Project Details:
Dalguise
Monkstown

Drawing Title:
Dalguise House Proposed Elevations

MKS-RAU-DH-ZZ-DR-A-203

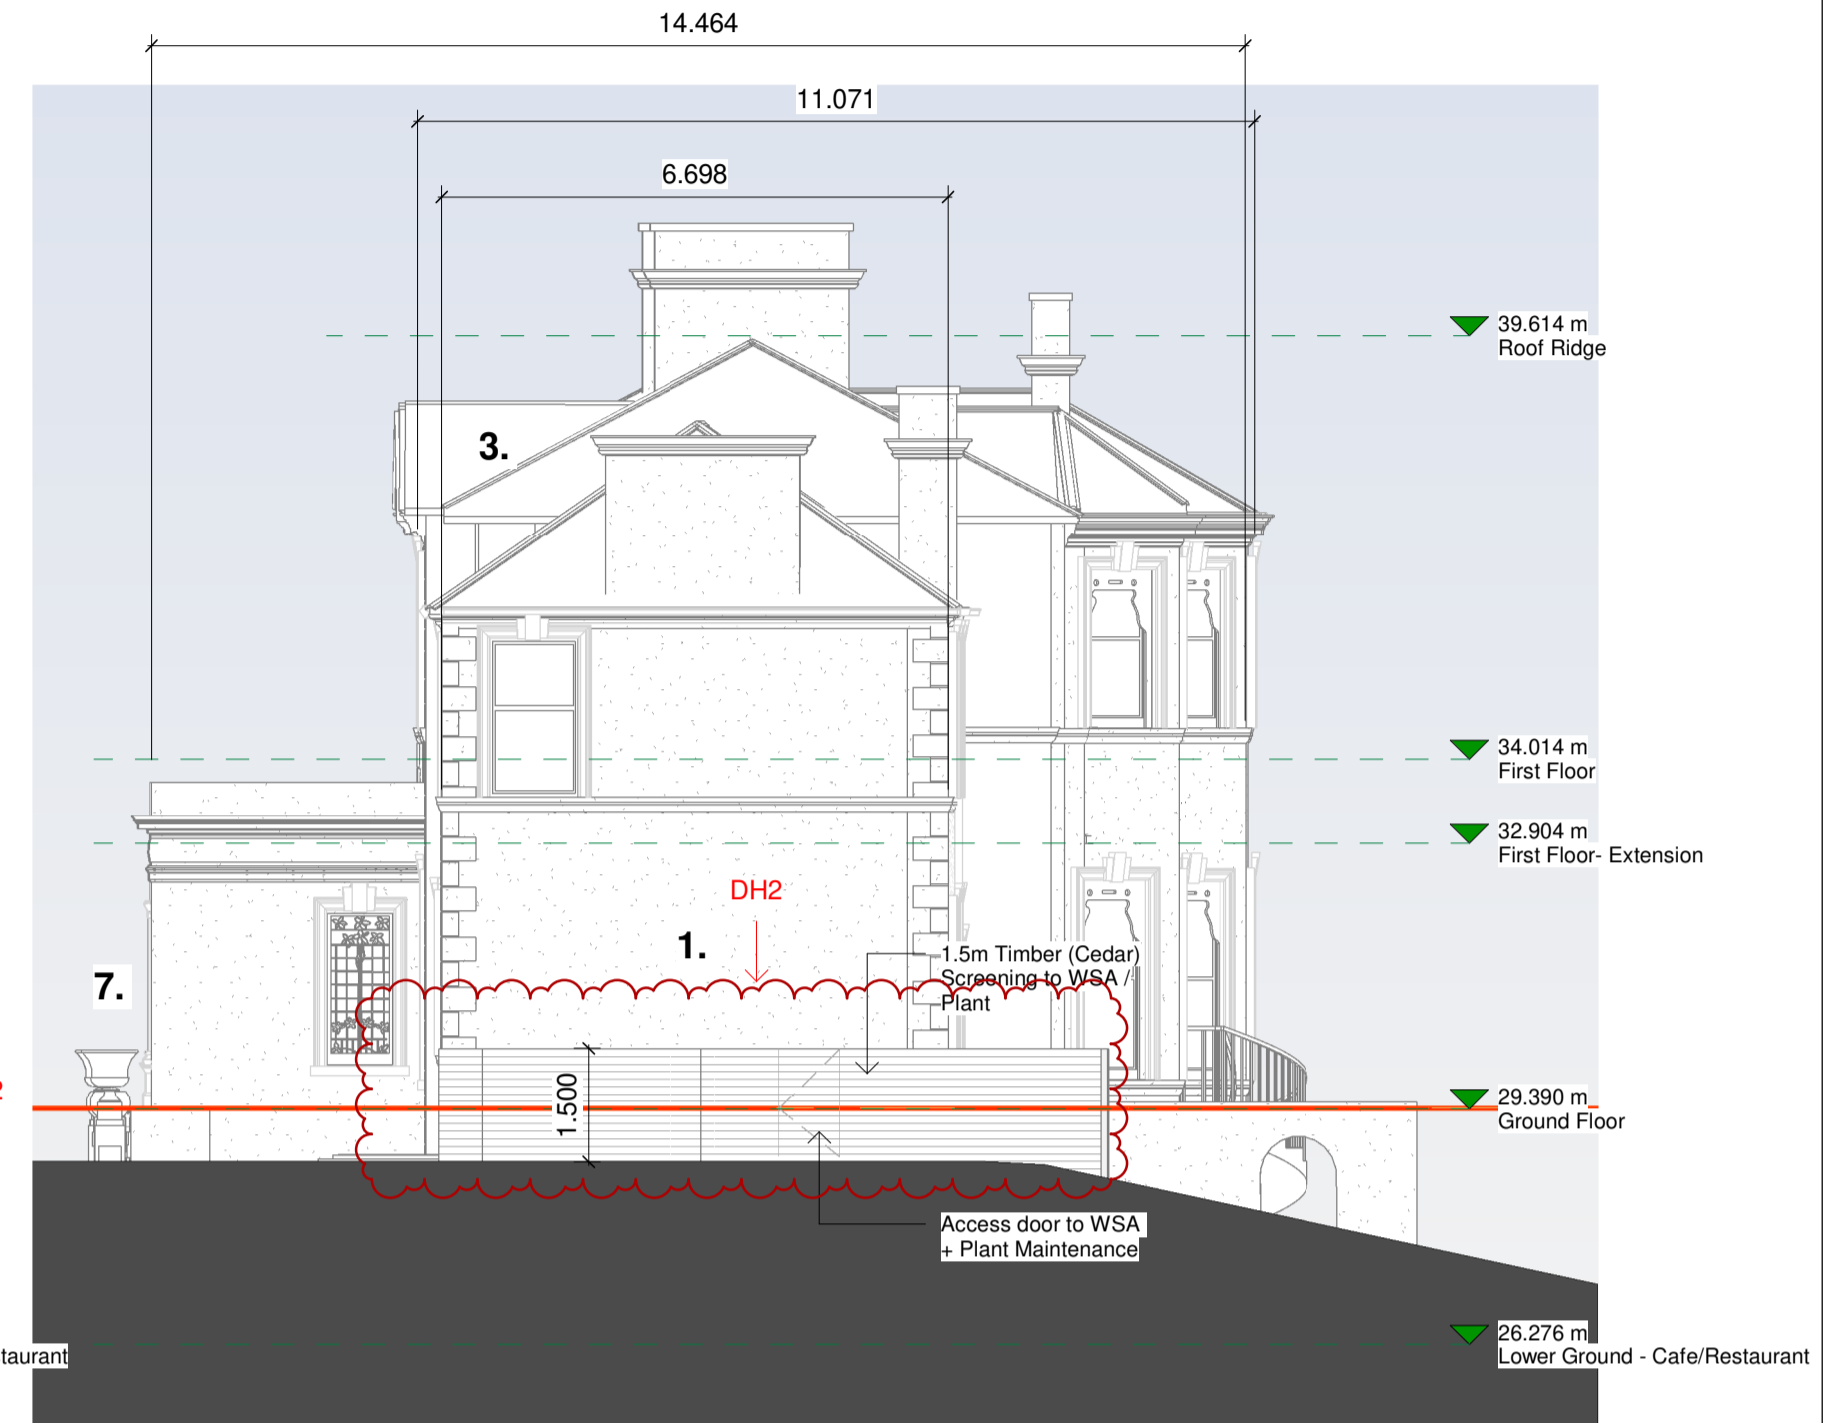
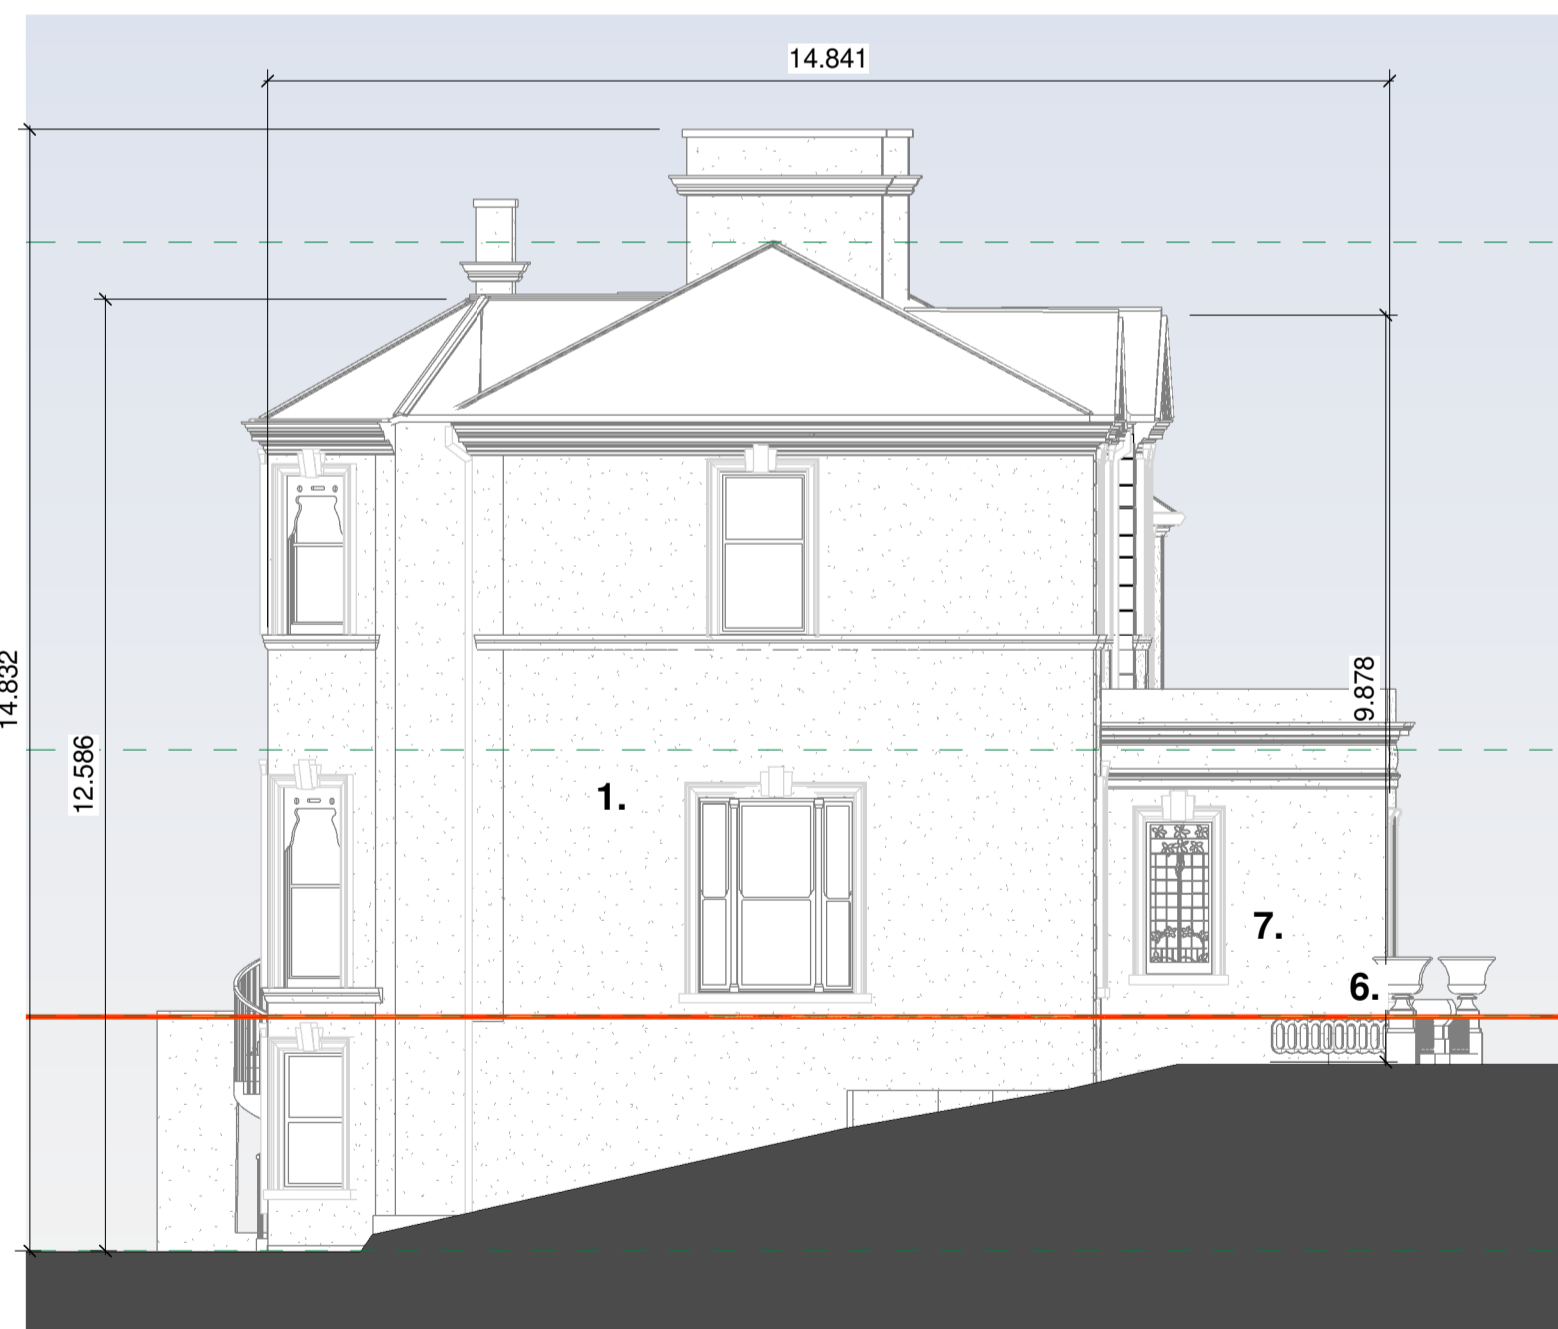
REVISIONS
DH1. Existing External Finish to be retained as per Item 9.
DH2. Timber Screen added to the side of Dalguise House to screen WSA / Plant.
